Dartron

Bulletin # SR-5R-0001

Ride Name: Zero Gravity

Bulletin # SB-5R-0906-01

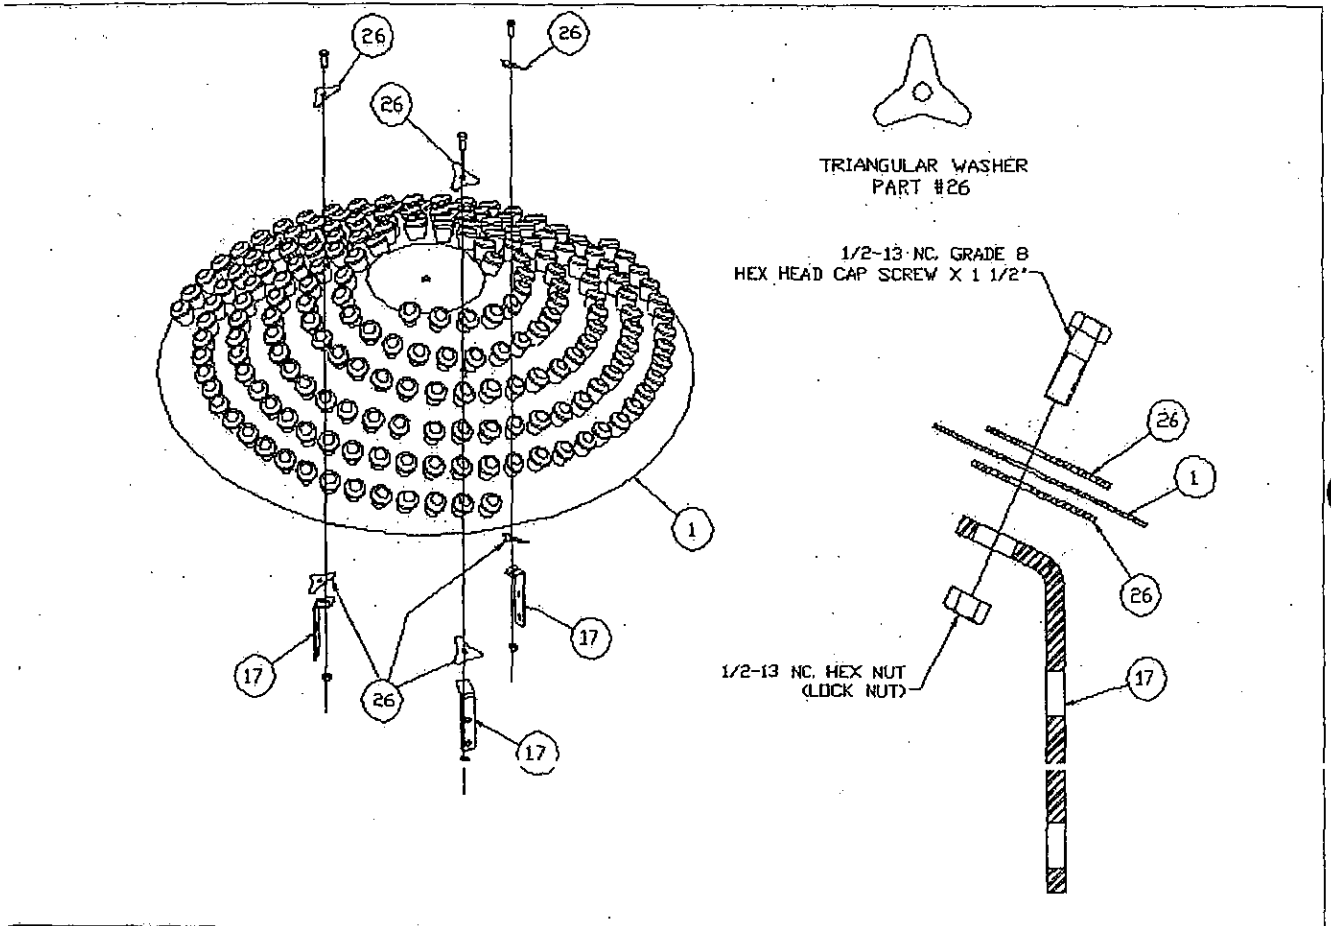
**Abstract of Issue:** Dartron is aware that the center column ornament light assembly can be torn loose from the center column with a strong head wind during transport.

**Reason for release:** Failure to update the existing mounting hardware for the center column ornament to the Dartron supplied hardware could result in it being torn loose from the ride during transport.

**Action to be taken:** Replace existing center column ornament light mounting hardware with the Dartron Industries provided hardware.

1. Remove and replace each set of mounting hardware individually.
2. Remove the current mount bolt, washer and nut at a single location on the center column ornament light assembly.

3. Re-install the mount bolt assembly using the Dartron provided hardware as shown below.
  - a. Replace the standard 1/2" washers with the Dartron provided triangular washer (#26) at the bolt head on the topside as shown below.
  - b. Place the second provided triangular washer (#26) on the bottom side between the mount bracket (#17) and the sheet metal of the ornament (#1) as shown on the following illustration.
  - c. Place the bolt through the hole on the mount bracket (#17) and install the provided Nyloc-type self-locking nut. See the following diagram.
4. Repeat these steps on the other two mount locations.

DARTKON IND., INC. P.O. BOX 13014 SALEM, OR 97309	TELEWOOD UNLESS NOTED	STORAGE RACK REINFORCEMENT	9-13-95	1 - 1	HM	
	REWORKS (FRACTIONS INCHES)					
	A = 1/2 C = 3/8 D = 1/4	AL/16	400	ZENDAR	BU7039	
					1/1	0

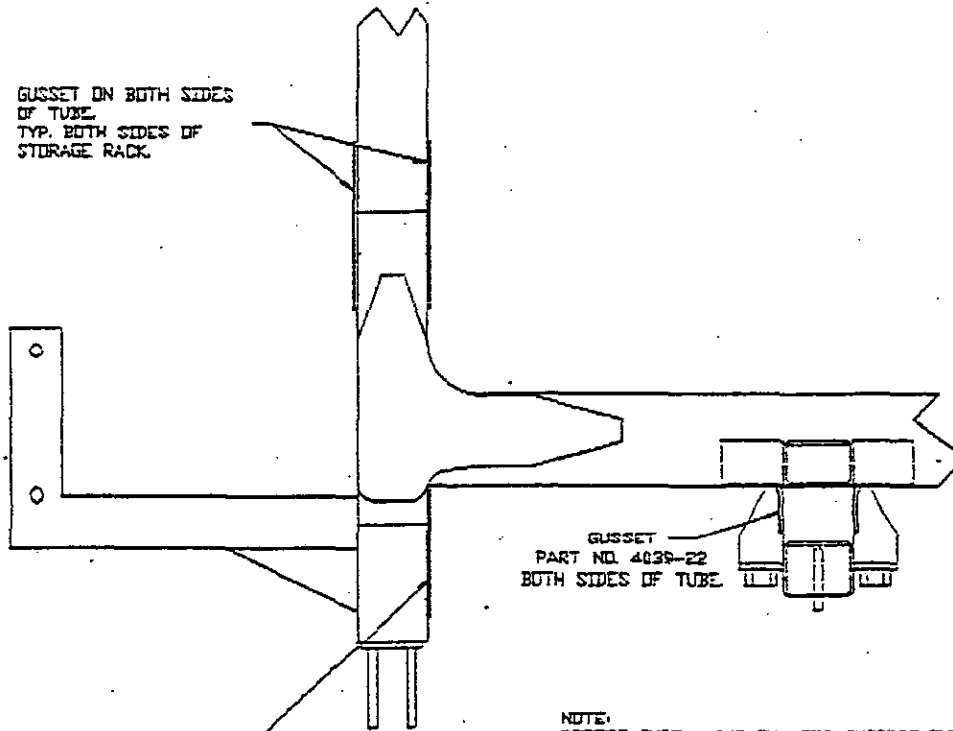
**Reason for release:** As a result of moving the Zendar long distances over rough roads, cracks could develop in certain welded joints in the front storage rack. If the cracks are not addressed, the joint could separate and cause the rack to drop during transit.

- Immediately inspect area shown on the attached drawings for cracking.
- If cracks are detected, immediately install gussets as shown in attached drawings.
- If cracks are not detected, gusset's still must be added no later than March 1, 1996.

GUSSET ON BOTH SIDES  
OF TUBE.  
TYP. BOTH SIDES OF  
STORAGE RACK.

GUSSET ON INSIDE WALL  
OF TUBE ONLY.  
TYP. BOTH SIDES OF  
STORAGE RACK.

NOTE:  
BEFORE INSTALLING GUSSETS, INSPECT TUBE  
JOINTS FOR CRACKS. IF A CRACK IN A JOINT  
IS PRESENT GRIND A 3/16" DEEP "V" GROOVE  
AT THE TUBE JOINT AND REWELD WITH A  
3/16" BEVEL WELD. THEN GRIND WELD FLAT  
AND INSTALL GUSSETS.
